SUNDRY NOTICES AND REPORTS ON WELLS

1. Type of Well					o. Well hame and no.	
☑ Oil Well ☐ Gas Well ☐ Other					TRISTE DRAW 25	FED COM 9H
2. Name of Operator CIMAREX ENERGY COMPANY OF COMPANY O					9. API Well No. 30-025-42198-00-X1	
3a. Address 202 S CHEYENNE AVE. SUIT TULSA, OK 74103	3b. Phone No. (include area code) Ph: 918.560.7060			10. Field and Pool or Exploratory Area TRISTE DRAW-DELAWARE

PECOS DISTRICT CONDITIONS OF APPROVAL

9H-Triste Draw 25 Fed Com

Cactus Multi-Bowl Wellhead Steps:

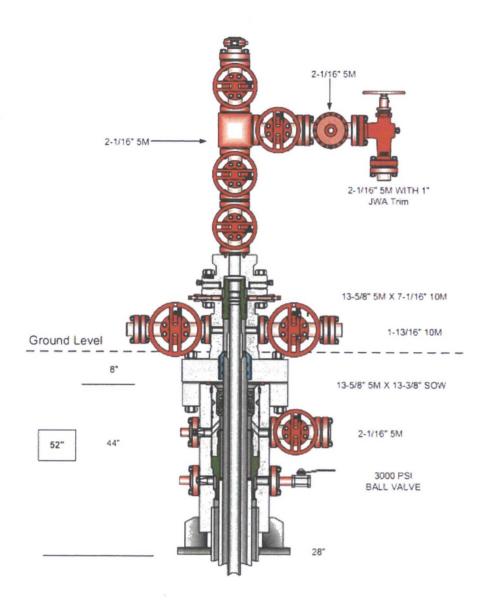
Operator has proposed a multi-bowl wellhead assembly. This assembly will only be tested when installed on the surface casing. Minimum working pressure of the blowout preventer (BOP) and related equipment (BOPE) required for drilling below the intermediate casing shoe shall be 3000 (3M) psi.

- a. Wellhead shall be installed by manufacturer's representatives, submit documentation with subsequent sundry.
- b. If the welding is performed by a third party, the manufacturer's representative shall monitor the temperature to verify that it does not exceed the maximum temperature of the seal.
- c. Manufacturer representative shall install the test plug for the initial BOP test.
- d. If the cement does not circulate and one inch operations would have been possible with a standard wellhead, the well head shall be cut off, cementing operations performed and another wellhead installed.
